Appl. No.: 10/689,955  
Applicant(s): Mileos et al.  
Filed: October 21, 2003

### REMARKS/ARGUMENTS

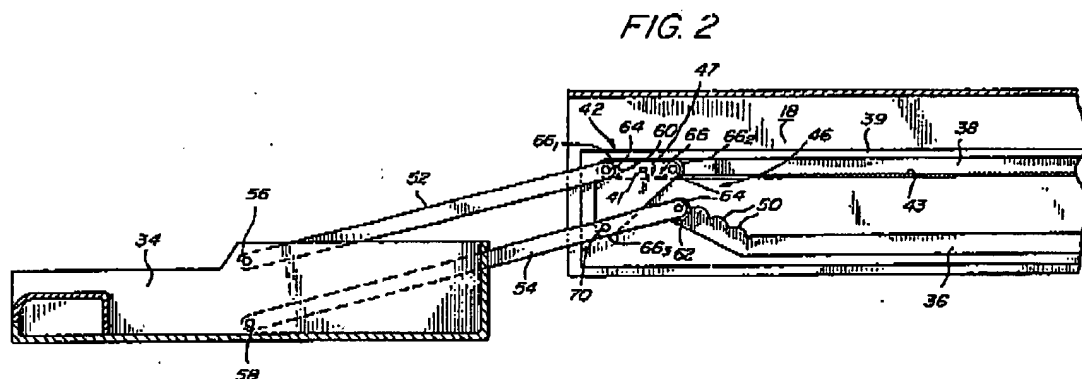
The Examiner rejected Claims 48, 49 and 92 as anticipated by U.S. Patent No. 5,302,015 to Du Vall. *Inter alia*, the Examiner asserts that the Du Vall discloses a "linkage is attached to the shelf (14) at a substantially centralized, interior point of the auxiliary shelf removed from the side edges (i.e. the links 52, 54 are attached to the shelf along the central longitudinal axis thereof, which is located interior of side edge 30 and the opposite side edge of the shelf) in a manner to prevent the shelf mechanism from

The Applicants respectfully submit that the Examiner has misconstrued the cited reference. Instead of the linkage attachment being at a substantially centralized interior point, the linkage is actually attached on the exterior of the shelf. Indeed, the only support the Examiner cites for her findings, findings that are arbitrary, capricious, and an abuse of discretion, is Fig. 2 of the Du Vall patent, which is reproduced below.

Alone, at best, Fig. 2 of the Du Vall patent is ambiguous. This figure does not support the Examiner's position because, while Fig. 2 clearly indicates that links 52 and 54 are on the other side of *side wall 34* (34 is identified as a side wall by Du Vall at, for instance, col. 3, ln. 64) – those portions of links 52 and 54 that overlap side wall 34 are shown in dotted lines to indicate they are on the other side of side wall 34. Consequently, one of ordinary skill cannot determine where on shelf 30 side wall 34 is located from Fig. 2 alone.

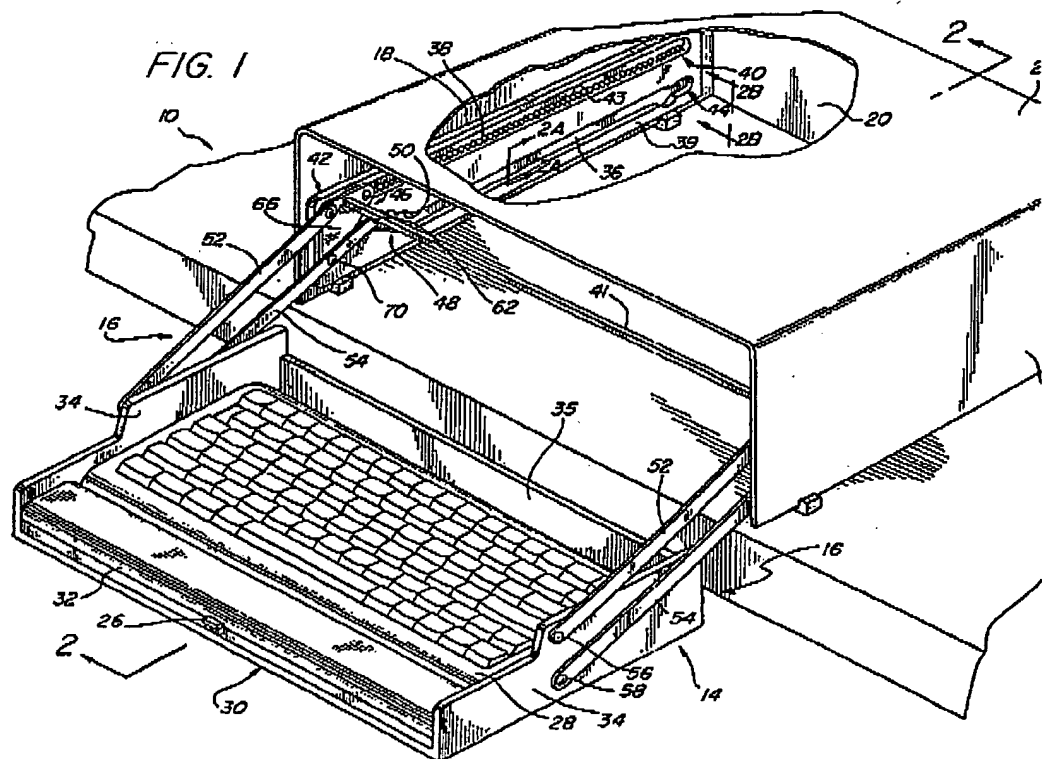
diverged and taught away from the invention at hand as well as disclosures that pointed towards and taught the invention at hand." *Ashland Oil, Inc. v. Delta Resins & Refractories, Inc.*, 776 F.2d 281 (Fed. Cir. 1985) quoting *W.L. Gore & Associates, Inc. v. Garlock Inc.*, 721 F.2d 1540, 1550 (Fed. Cir. 1983), cert. denied, 105 S.Ct. 172 (1984). To understand Fig. 2, the Applicants respectfully submit that one must use Fig. 1 (which is reproduced below in pertinent part) of the Du Vall patent as a guide.

Indeed, Du Vall states that "FIG. 2 is a side cross-sectional view of the embodiment of FIG. 1 taken along line 2--2". Col. 2, ln. 65-66. In this context, the Applicants respectfully submit that left side links 52 and 54 of the device disclosed in the Du Vall patent are on the extreme lateral exterior of shelf 30, beyond side wall 34. This

extreme lateral exterior position for attaching the links to the shelf structure is expressly illustrated on the right side of the Du Vall device in Fig. 1.

Fig. 3.

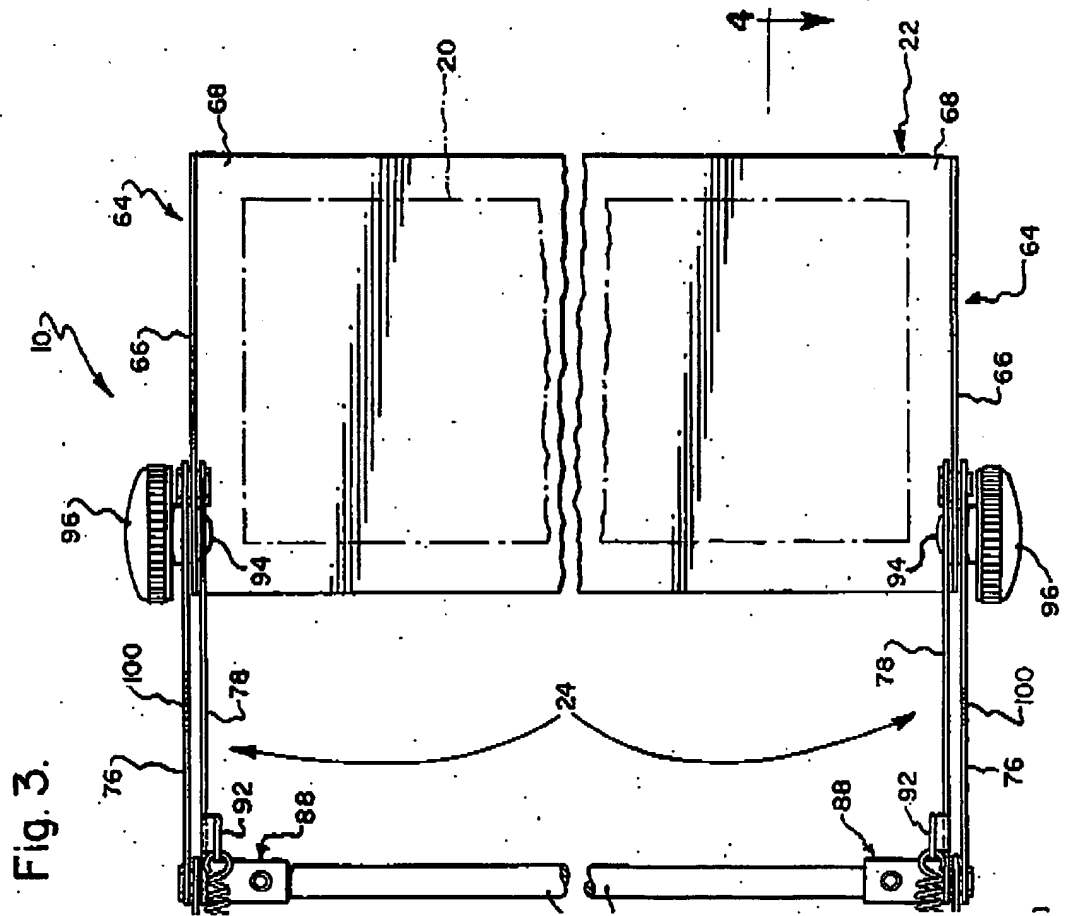
However, Fig. 2 does provide information that is inconsistent with finding that the Watt reference teaches attaching the linkage arms "near the middle" of the shelf. Specifically, Fig. 2 identifies the plane of view for, *inter alia*, Figs. 3 and 7. Any evaluation of Fig. 2 concerning the position of the attachment between the **links (76 & 78) and upstanding plate portions 66** without due consideration of both Figs. 3 and 7 is arbitrary, capricious, and an abuse of discretion.

In contrast to the unknown position of the view upon which the Examiner relies — Fig. 2 —, Fig. 3 is a view taken in a plane just above the auxiliary shelf. See line 3—3 in Fig. 2. Consequently, Fig. 3 (unlike Fig. 2 upon which the Examiner improperly relies) shows the relationship of the linkage arms (76 & 78) to the edges (**upstanding plate portions 66**) of the shelf bracket of the device disclosed in the Watt patent. In Fig. 3 (reproduced below in pertinent part) it is apparent that the linkage arms (76 and 78) are attached to **upstanding plate portions (66)** at (one arm on either side of the upstanding plate), and not away from, the side edges (64).

Thus, when the Watt reference is properly applied, it does not teach the subject matter of Claims 48, 83, 86, 87 and 94. Therefore the anticipation rejection based upon Watt must be withdrawn.
